ALERT SERVICE BULLETIN No. 081 Rev. A

Alternator Castellated Hex-Nut Inspection

1. This page transmits the revision of Alert Service Bulletin (ASB) 081 Rev. New to ASB 081 Rev. A, dated September 19, 2019.
 - A. ASB 081 Rev. New, dated August 06, 2019

Figure 1 - Alternator, Typical - Continental Aerospace Technologies

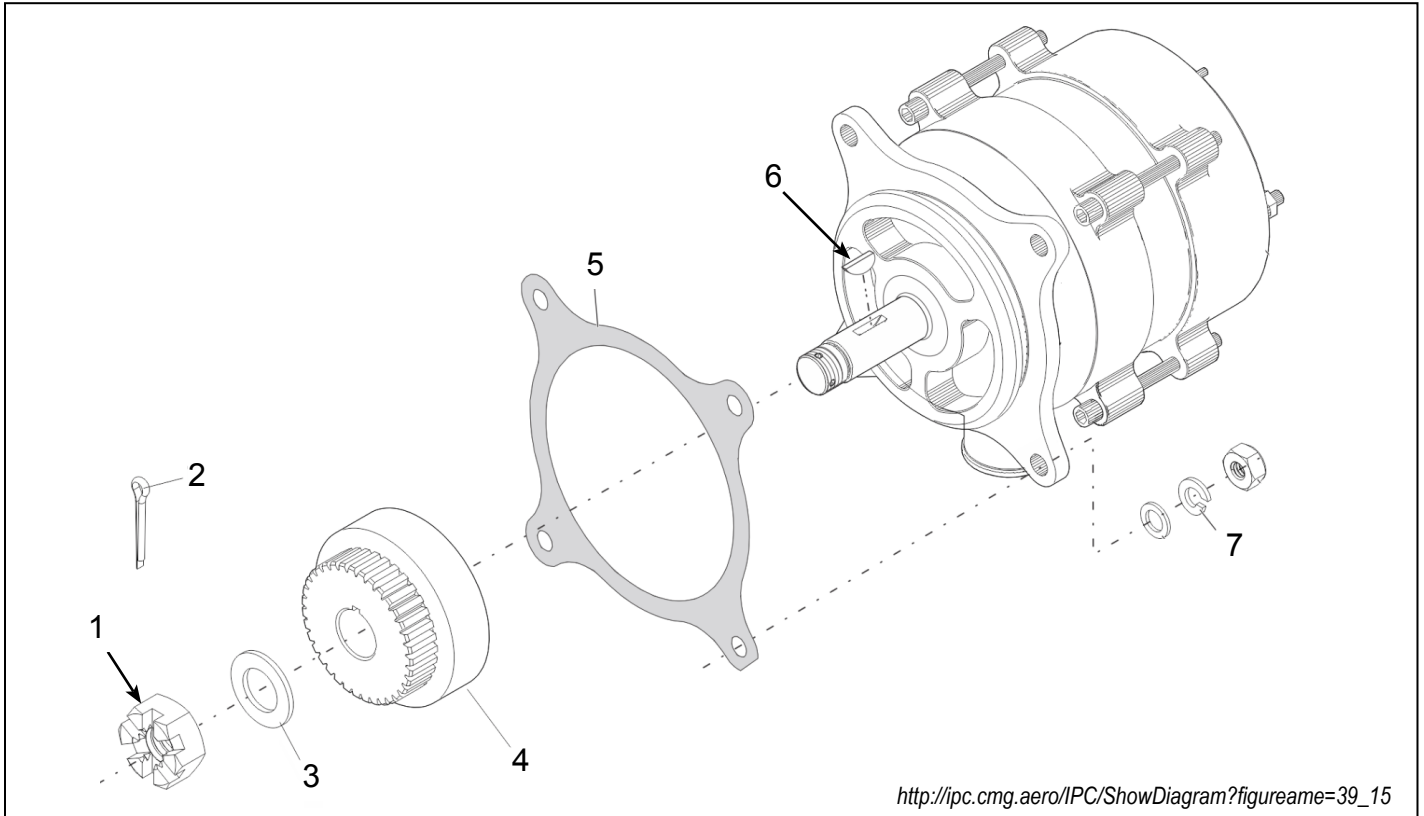
4. This revision is issued to change the following:
 - A. Correct part number typo, Table 1, Materials Required:
 - (1) Change thrust washer P/N 63097 to 63091 (Table 1, ITM# 3).

Figure 4 - Roll-Stamped "AD"

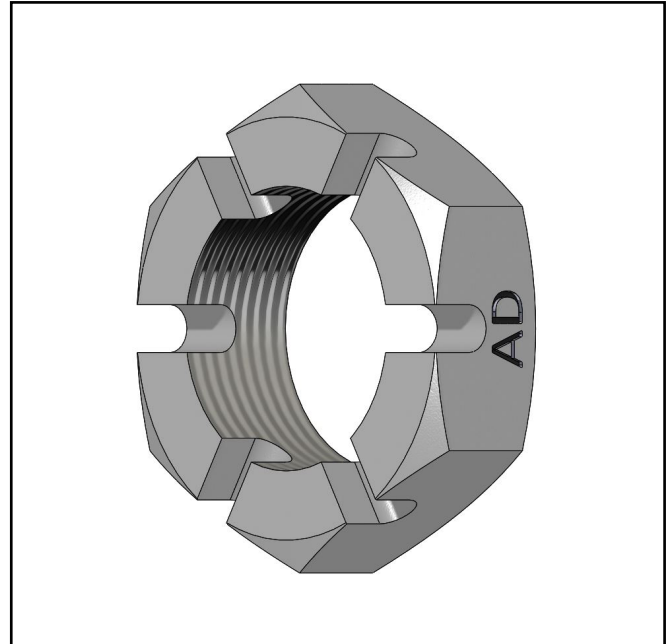
- B. Revise 3.B.2.(c) to reflect change to Figure 4:
 - (1) Change to: Hex-nut (1) is roll-stamped with the letters "**AD**".
 - C. Add task 3.B.(6) for clarification:

- (1) Inspect drive coupling (4) in accordance with applicable service instructions.
 - D. Change Figure 4 from Machined Groove to Roll-Stamped "**AD**" and update illustration.
